工程指示 / 要求簡箋(E.I.)

工程指示編號：EI / 3175 / 21

工程名稱：亞皆老街中電

工程項目：佛沙窗 地盤用玻璃 B.M. 大貨 (T1-T3) (1-21/F) (3006 件)

伟创窗 T1-T3: 1-21/F 磨砂玻璃位置

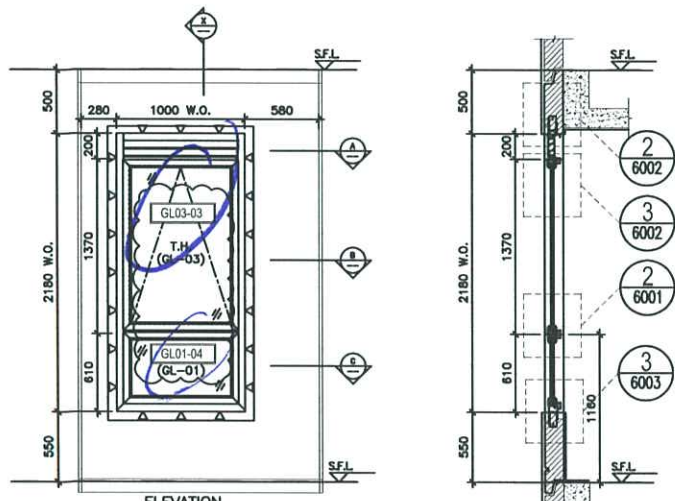
E 版：因則師要求修改磨沙玻璃位置，請留意部份磨沙的玻璃改為清片。

-  磨砂玻璃位置
-  磨砂改 清片玻璃

FIRST FLOOR PLAN (1/F)

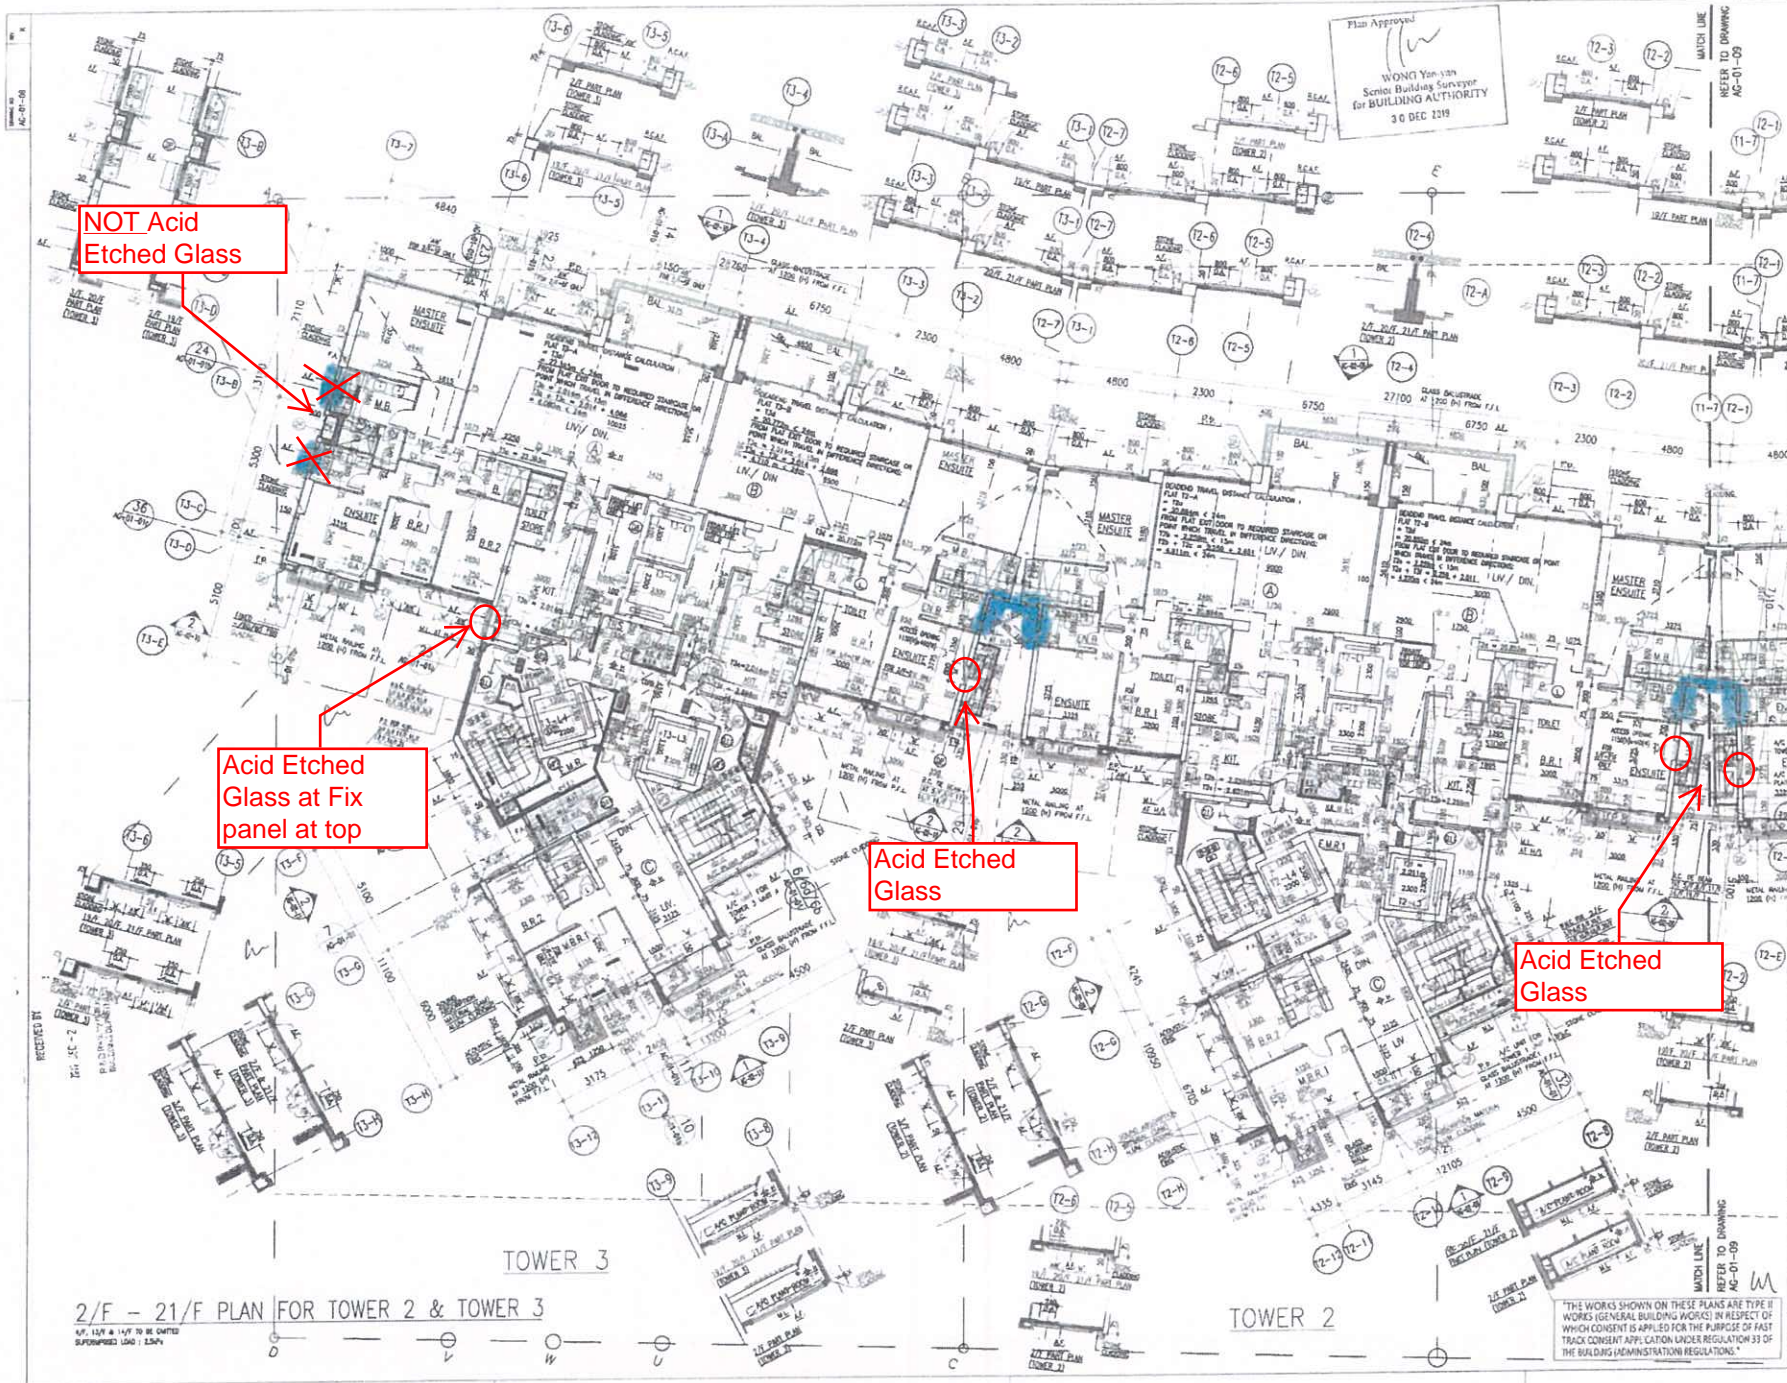
Please note that the location plan of acid etched glass to be used attached in your submission is INCORRECT. Please refer to attached markup for your further action. An updated location plan shall be attached to this submission for our approval.

NOT Acid Etched Glass

NOT Acid Etched Glass

Acid Etched Glass at Fix panel at top

Acid Etched Glass

Acid Etched Glass

Acid Etched Glass at Fix panel at top

22nd FLOOR PLAN
(SHEET 1)

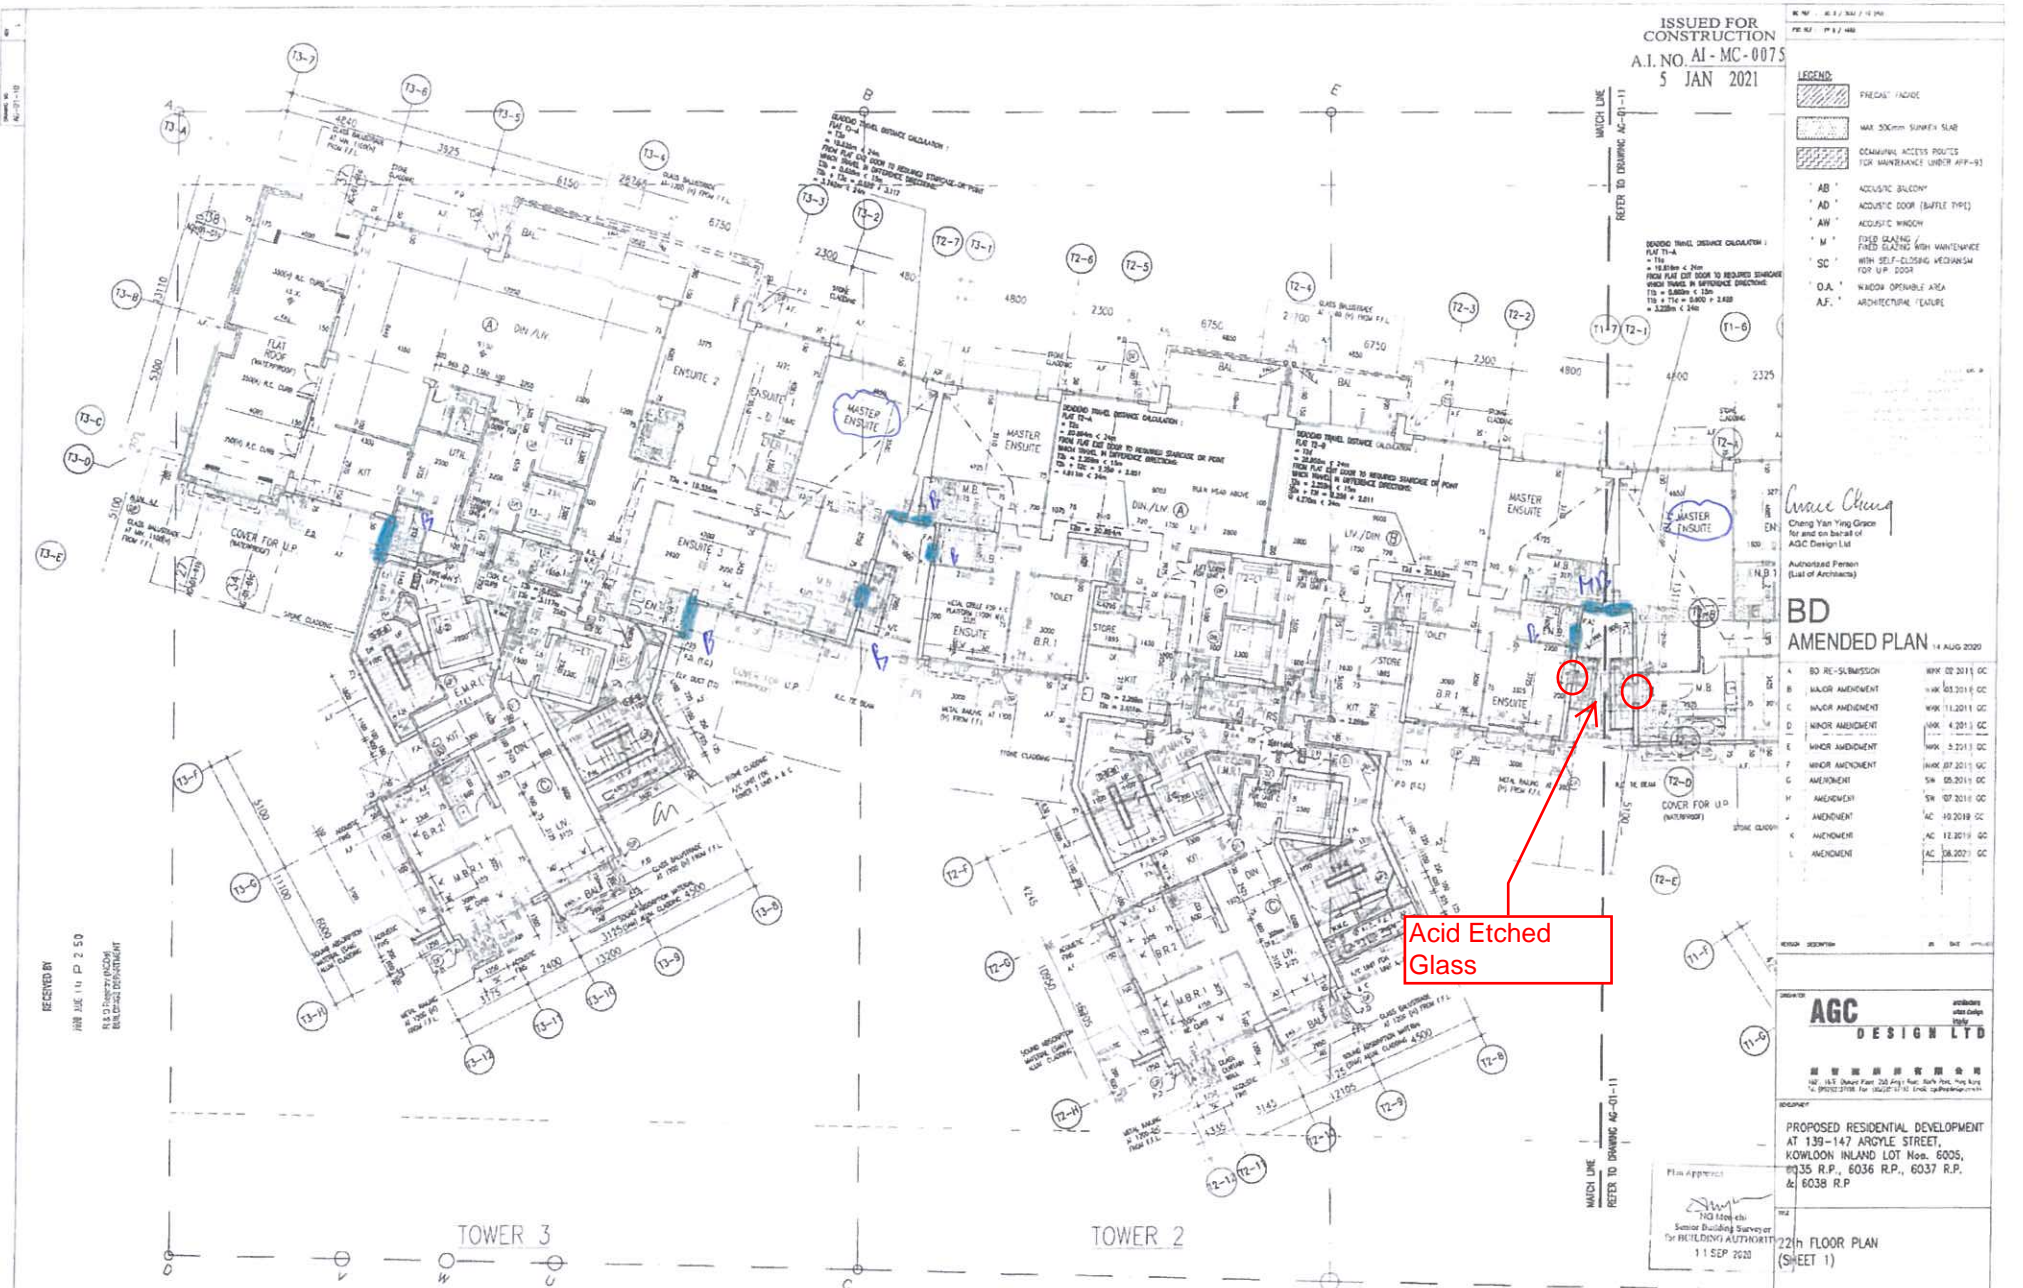
Acid Etched Glass

22th FLOOR PLAN
 (SHEET 2)

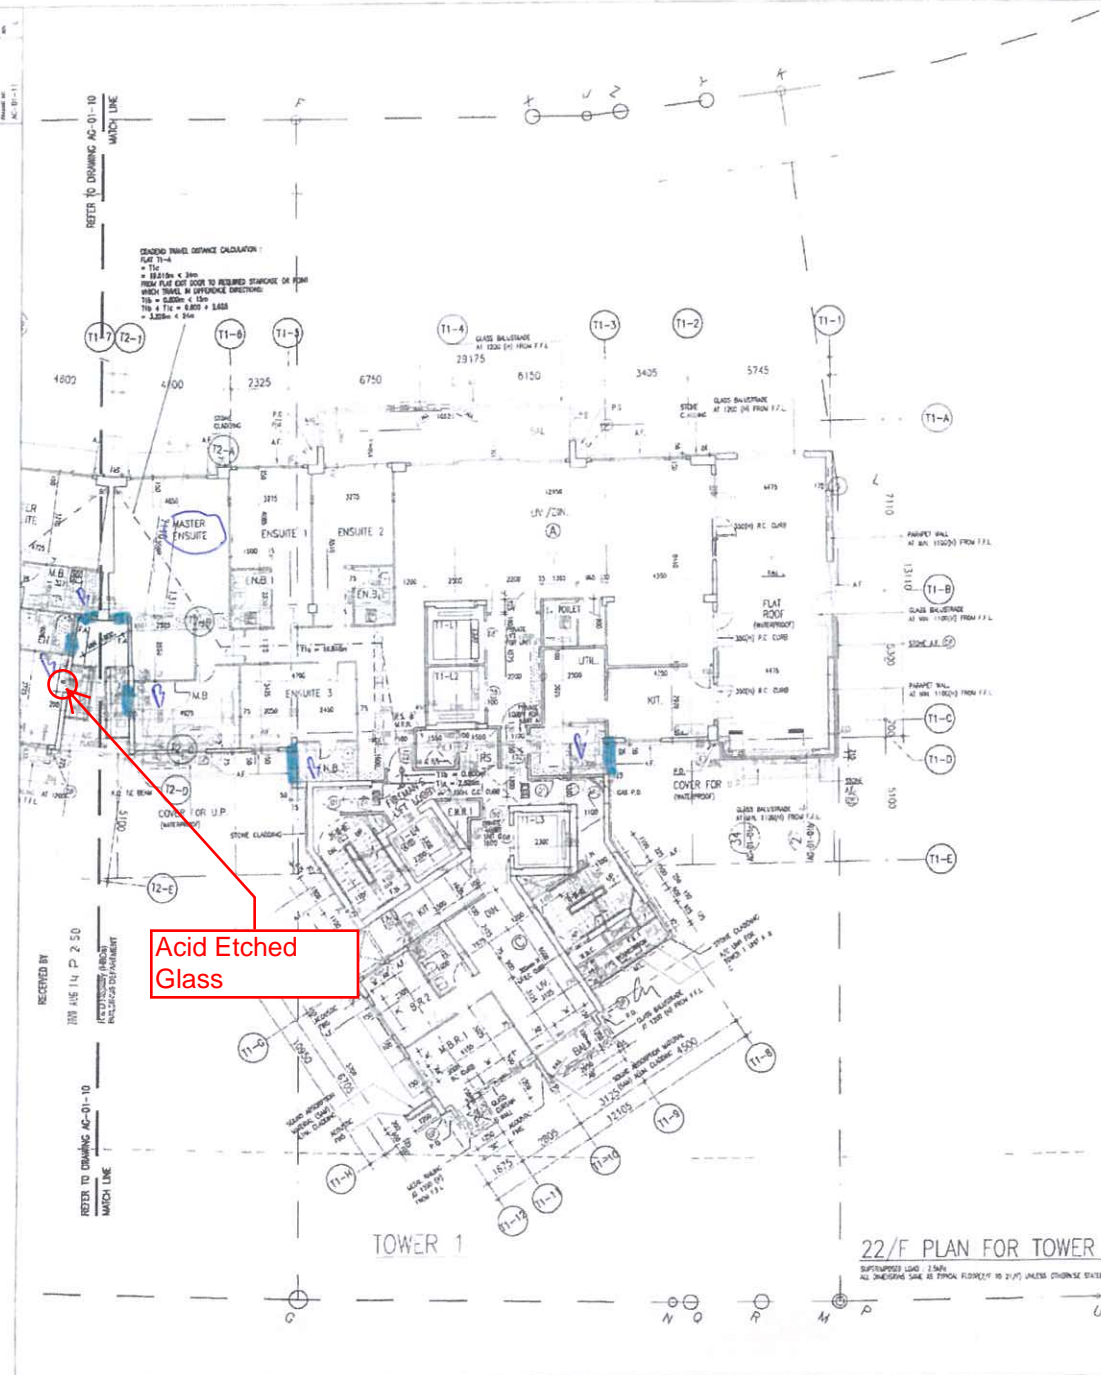
Acid Etched Glass
